Service Bulletin

TAT SB07-01

Model SR22 w/ Turbonormalizer

The purpose of this Service Bulletin is to inform affected owners and operators of a product improvement to the Turbonormalizing System that requires the installation of a support bracket for the wastegate control linkage and possible replacement of attaching clevis pins.

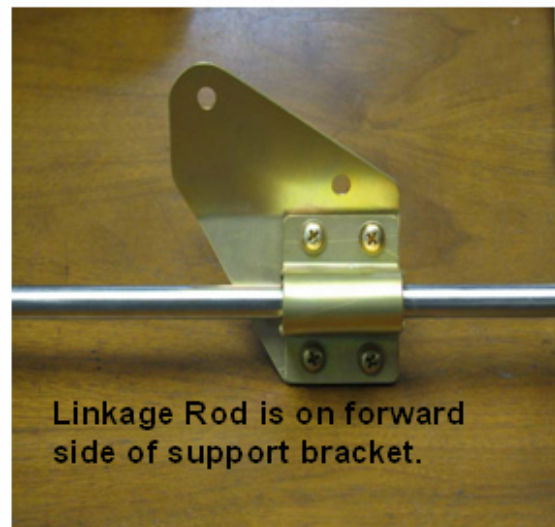
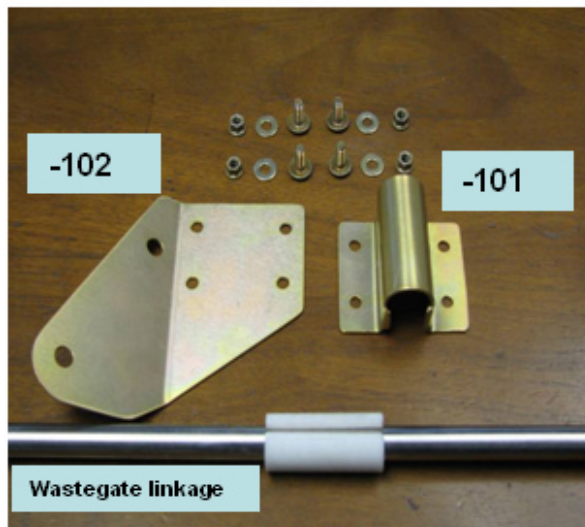
Installation of Wastegate Linkage Support Bracket

- Snap Teflon® bushing FS-895 over the long run portion of the wastegate linkage ETI-SR22-111-1. This can be done with the linkage arm installed on the aircraft and without removing the linkage or disassembly of the linkage.
- Place retainer cap ETI-G2-112-101 around bushing.
- Place mount plate ETI-G2-112-102 to aft side of retainer cap with bent angle towards retainer cap.
- Install 4 screws AN525-832R6 through forward side of retainer cap towards the mount plate.
- Install 4 washers NAS1149FN832P and 4 nuts MS21042-08 from aft side of plate and tighten to 35 inch lbs (3.9 Nm).
- Slide assembly along linkage and move fore and aft to ensure the linkage can articulate left and right and with fore and aft movement with no binding of the mechanism.

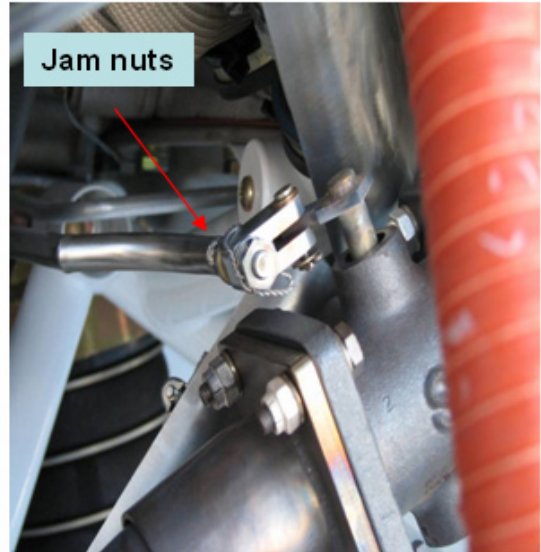
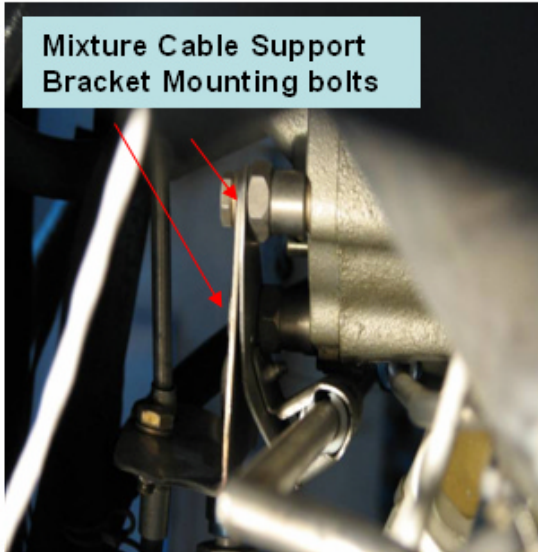
- Gain Access to the mixture cable support bracket and locate two (2) bolts identified below.

- Remove the 2 bolts that secure the mixture control cable bracket to the starter drive adapter.
 - Place wastegate linkage support bracket between the mixture bracket and starter drive adapter and reinstall bolts.

- Torque bolts **50 to 70 inch lbs (5.6 to 7.9 Nm)**.
 - Hand actuate the linkage to ensure freedom of movement.
 - If the linkage rod is not closely aligned with the support bracket and movement of the linkage is not free, loosen the jam nuts on each end of the linkage to allow the linkage to rest neutrally within the support bracket and retighten the nuts and secure with safety wire.

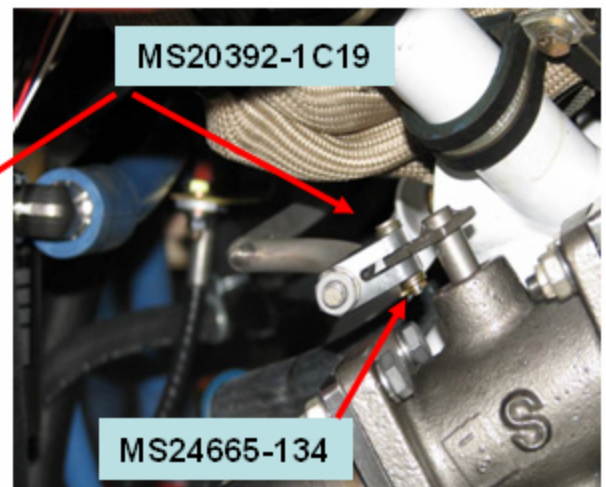
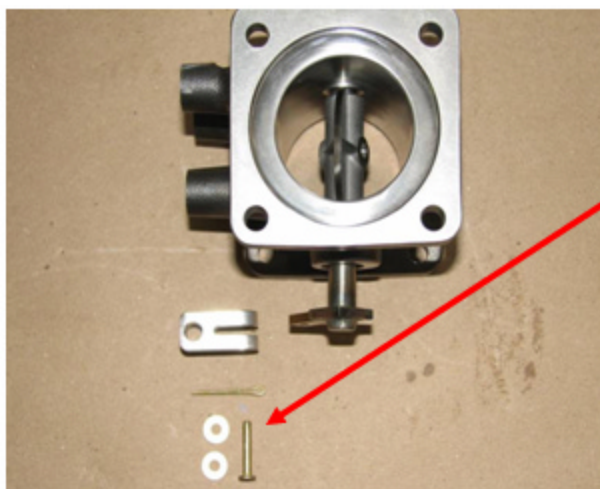
3. If the aircraft **has more than 60 hours time in service**, also perform the following:
 - If the aircraft has more than 60 hours time in service since installation of the Turbonormalizing System, then prior to installing the new wastegate linkage support bracket ETI-G2-112-1, inspect for possible wear to the clevis pins MS20392-1C19 caused by linkage flapping, as follows:

- Inspect the pins at both wastegates by removing cotter pin and sliding pin out. Be sure to retrieve the washers.
 - Replace the pin with new, regardless of condition.

- Note the condition of the clevis hole and wastegate arm. Some wear is normal and is acceptable.
 - Install new clevis pin with 2 washers, and new cotter pin MS24665-134.
